BID CLARIFICATION 3 FOR
REQUEST FOR PROPOSALS FOR
NEXUSPARK FIELDHOUSE DESIGN/BUILD

Columbus, Indiana

Issued: April 8, 2022

E01-01

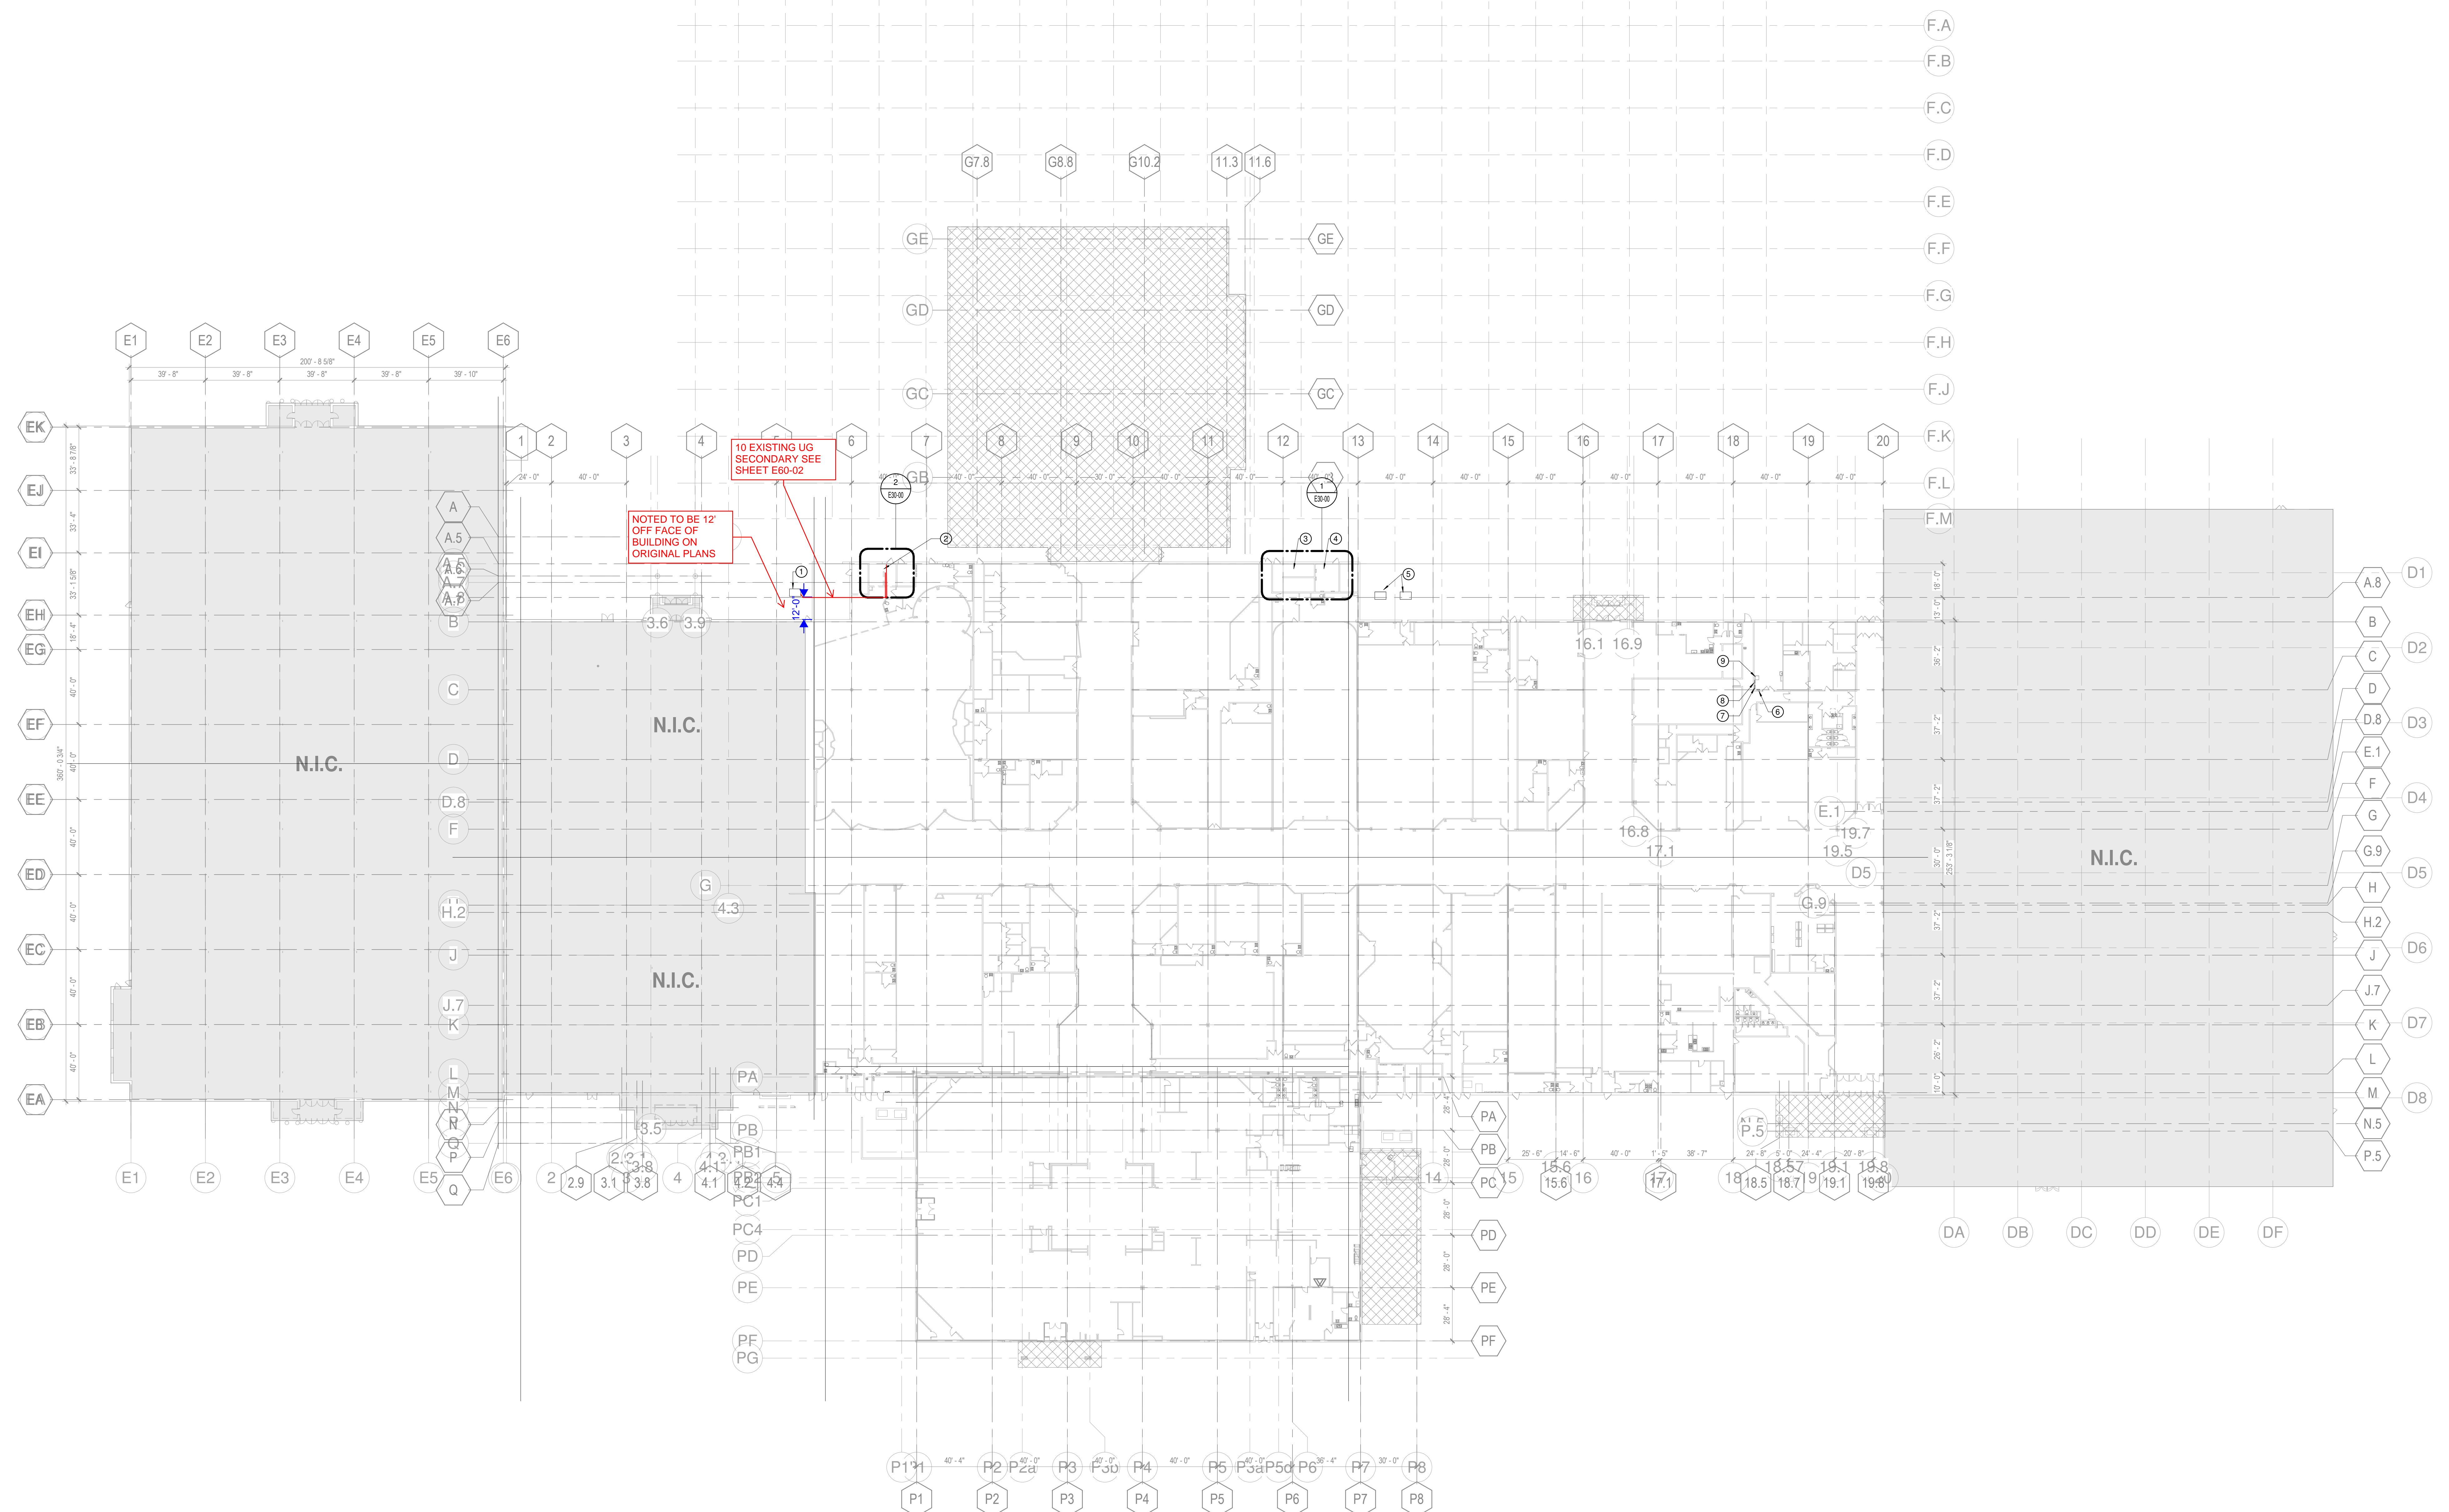
Question F41: Sheet E60-02 shows to intercept (10) existing 4" underground conduits encased in concrete and reroute, but it is not shown on any site drawing as to where it is or the route it needs to go. Please clarify

Answer: See mark up of page E01-01. See also mark up of page E12-01 for proposed route of new 480 volt feeder.

TITLE
ELECTRICAL POWER PLAN - SECTOR B - ENABLING PHASE
SHEET NUMBER
E12-01

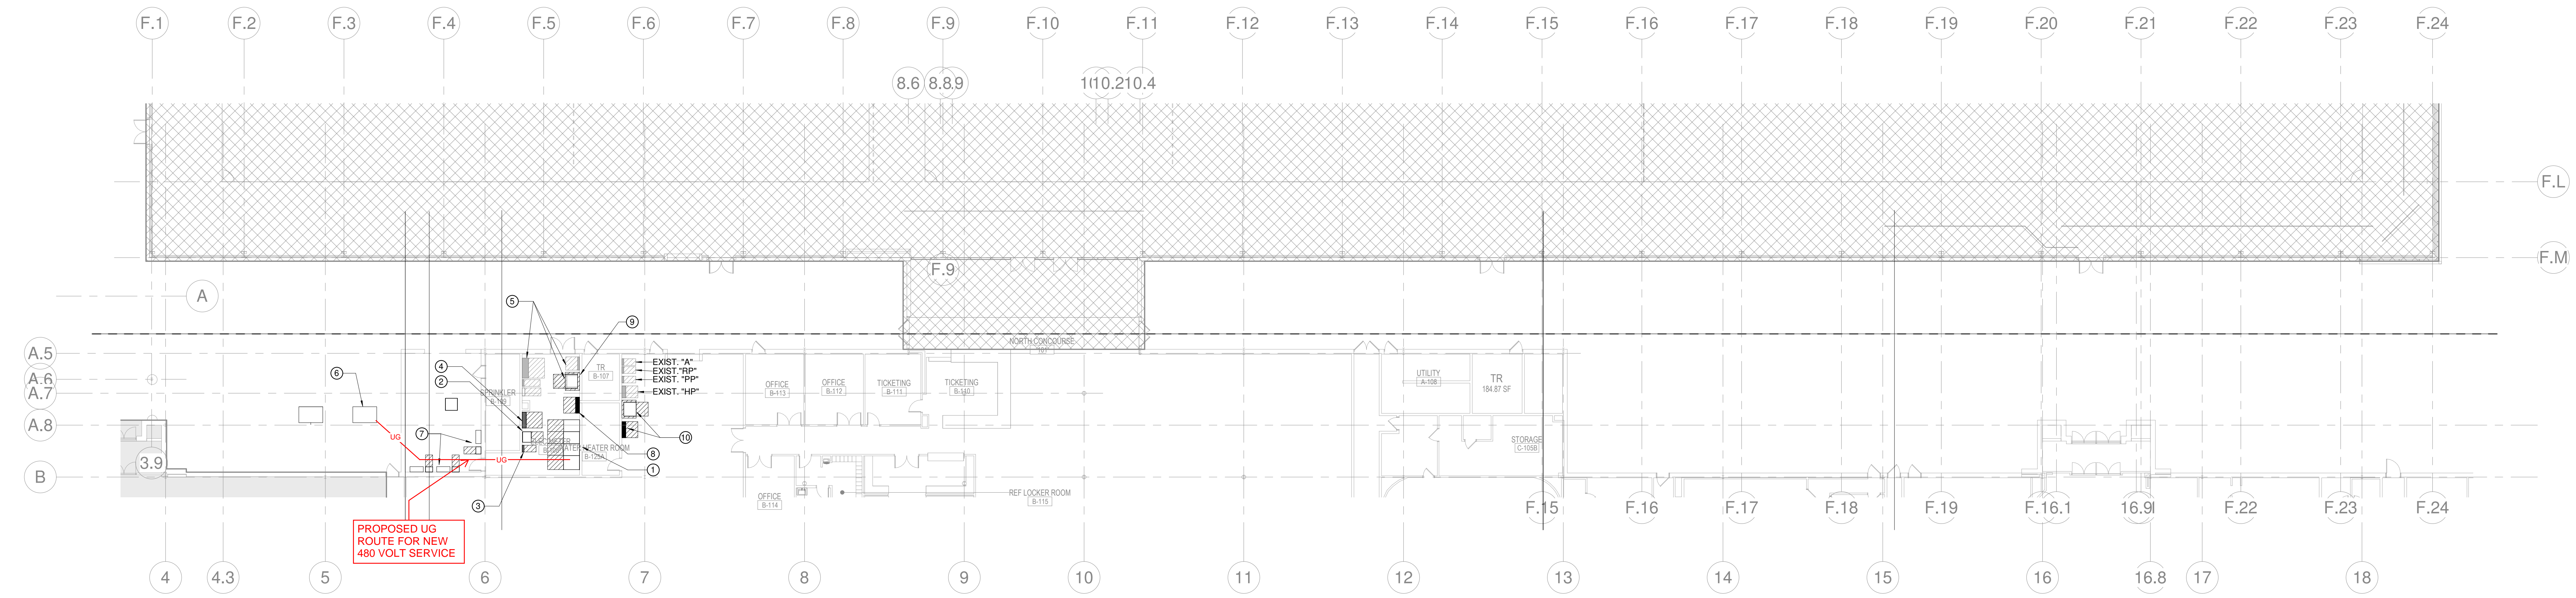
Question F42: Sheet E60-02 Detail 1 shows the intercepted conduits to go to the CT cabinets. Will these cabinets mount outside of existing meter room 209?

Answer: CT Cabinets are to be located outside electrical room B-108 as shown on sheet E12-01, reference note no. 7
